**Petition No. 1401  
Revity Energy LLC  
Plainfield and Sterling, Connecticut  
DRAFT Staff Report  
July 10, 2020**

On April 17, 2020, the Connecticut Siting Council (Council) received a petition (Petition) from Revity Energy LLC (Revity or Petitioner) for a declaratory ruling (petition) pursuant to Connecticut General Statutes (CGS) §4-176 and §16-50k for the construction, operation and maintenance of a 12.25 megawatt (MW) alternating current (AC) solar photovoltaic electric generating facility on approximately 74.9-acres located at 424 Snake Meadow Road, Plainfield and 0 Valley Road, Sterling, Connecticut.

**Figure 2**  
**Existing Conditions Map**

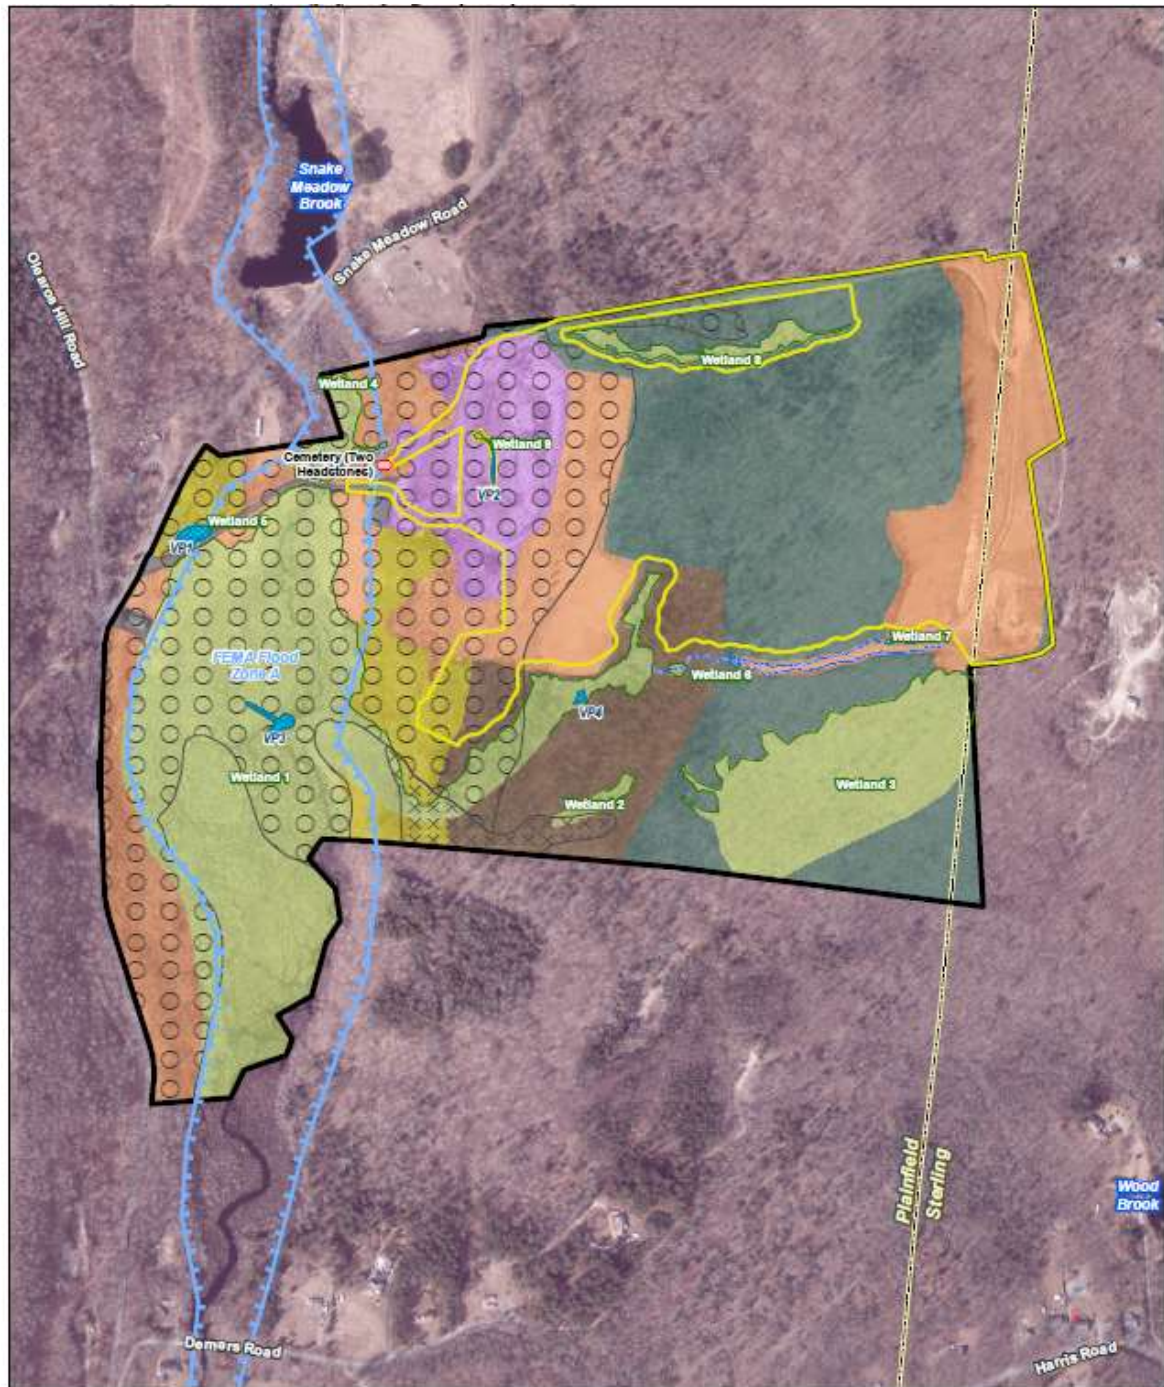
The subject property contains prime farmland soils according to mapping maintained by the United States Department of Agriculture (USDA) Natural Resource Conservation Service (NRCS). Under PA 17-218, “prime farmland” means land that meets the criteria for prime farmland as described in 7 Code of Federal Regulations (C.F.R.) 657, as amended from time to time. 7 C.F.R. 657 defines prime farmland in relevant part as “land that has the best combination of physical and chemical characteristics for producing food, feed, forage, fiber, and oilseed crops, and is also available for these uses.” However, all project development would be located outside of the mapped prime farmland soils. See attached Existing Conditions Map.

### **Forestland Habitat Impact Map**

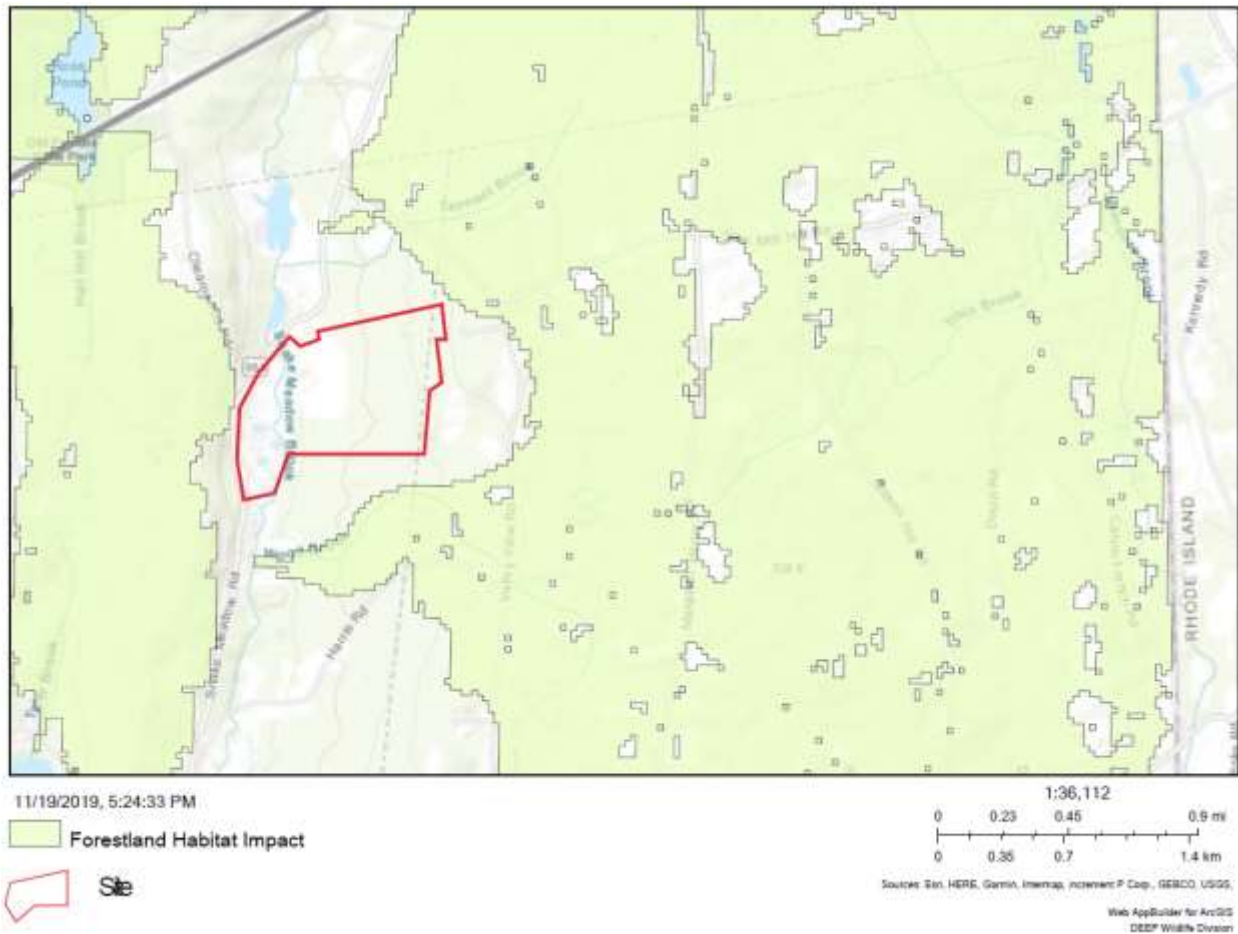
However, according to DEEP’s Forestland Habitat Impact Map, the site is not included within an area mapped as core forest. See attached Forestland Habitat Impact Map. By letter dated April 27, 2020, pursuant to PA 17-218, DEEP indicated that the proposed project will not materially affect the status of core forest.

**Figure 7**  
**Vernal Pool Analysis Map**

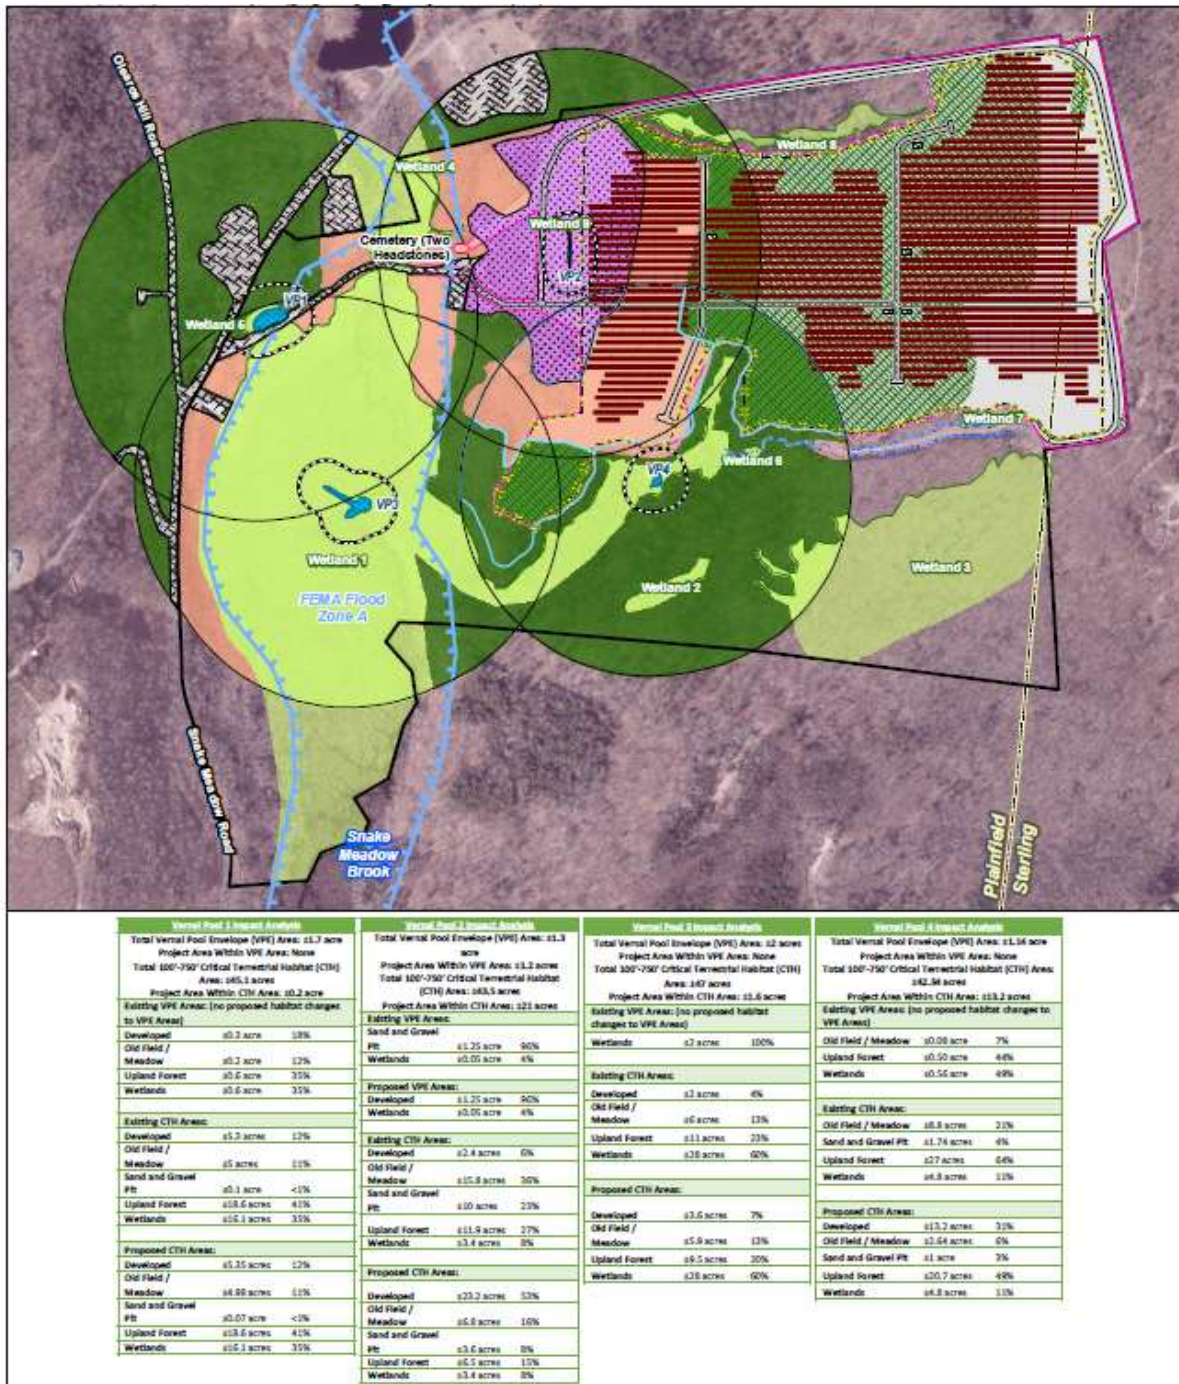
Vernal pool surveys were conducted on April 11, 2019; April 26, 2019; May 7, 2019; and May 29, 2019. A total of four vernal pools were identified at the site. See attached Existing Conditions Map. Indicator species observed, egg mass totals, and wetland locations of such vernal pools are identified below in Table A.

The methodology used to assess potential impacts to vernal pool habitats is consistent with the 2015 U.S. Army Corps of Engineers Vernal Pool Best Management Practices (ACOE BMPs). All four vernal pools assessed on the site currently maintain less than 25 percent development with the 100-foot to 750-foot Critical Terrestrial Habitat (CTH) area. Post-development, Vernal Pool Nos. 1 and 3 would remain below 25 percent development of the CTH area, while Vernal Pool Nos. 2 and 4 would exceed the guideline

threshold of 25 percent. However, the CTH surrounding both Vernal Pool Nos. 2 and 4 where development is planned are dominated by sub-optimal habitat, including actively disturbed areas. Additionally, the long-term viability of Vernal Pool No. 2 is questionable due to its man-made nature within an active gravel mine and the surrounding conditions. With respect to Vernal Pool No. 4, incorporating the ACOE BMPs vector analysis procedure suggests that much of the optimal upland forested habitat supporting this pool within its CTH exists to the south which would remain unaltered post-development. While there is potential for short-term impacts to herpetofauna associated with nearby vernal pool habitat, such short-term impacts associated with proposed development within vernal pool CTH areas would be minimized by the use of E&S controls consistent with the 2002 Connecticut Guidelines and the implementation of the WVPPP.

## Viewshed Map

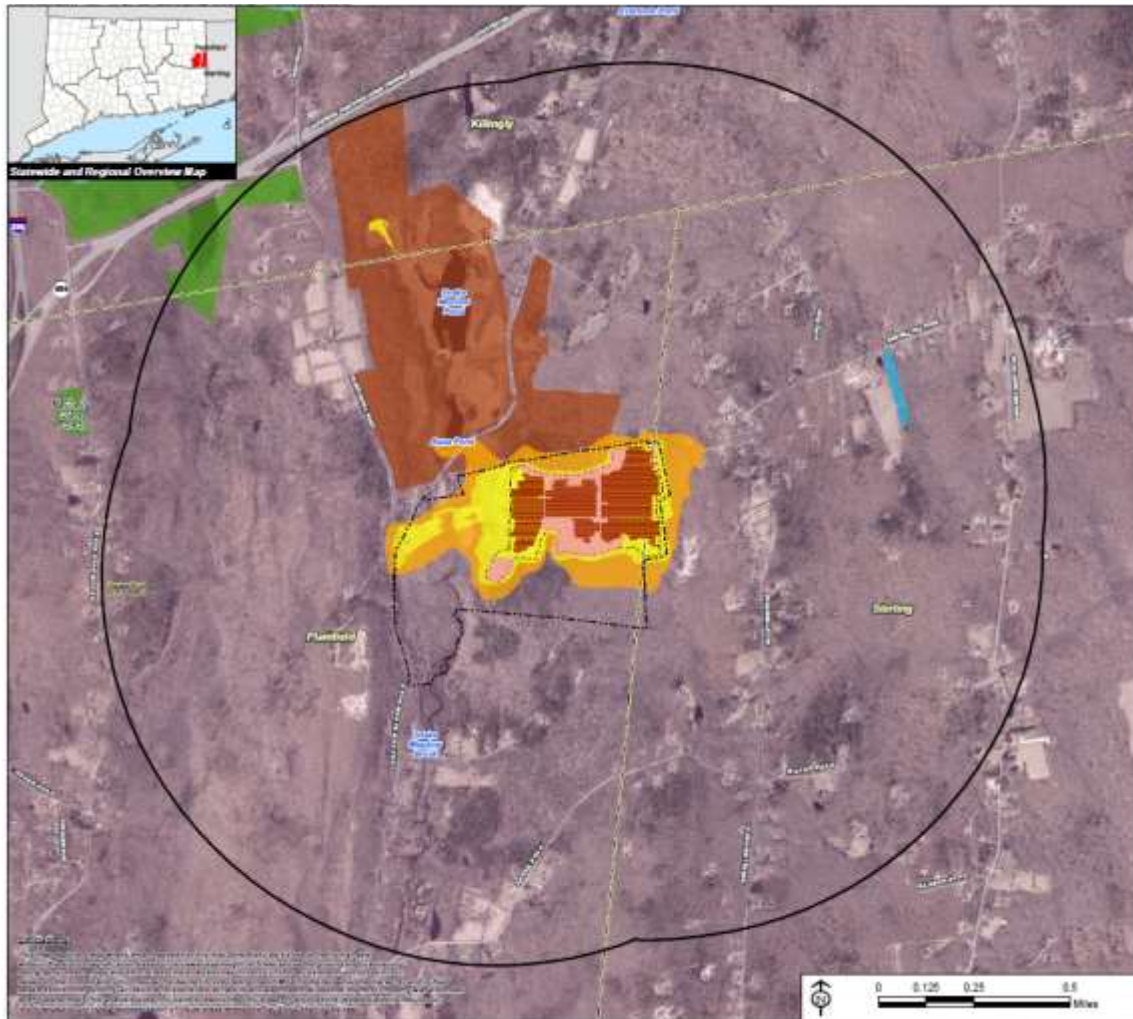
Year-round views of the facility from off-site locations would be limited to a small area along the east side of Snake Meadow Road directly west of the facility. Additional year-round visibility would also occur from the north at an elevated location northwest of Snake Meadow Pond in Killingly where the existing access road and current mining operations result in a lack of vegetation. Seasonal views of the facility are anticipated from locations immediately west along Snake Meadow Road and from portions of abutting properties to the east and north; however, such views would be through existing mature vegetative screening. In general, the project would be set back sufficiently from abutting properties and other roads such that, given the substantial intervening vegetation, the facility components would not be visible from most off-site locations. See attached Viewshed Map.
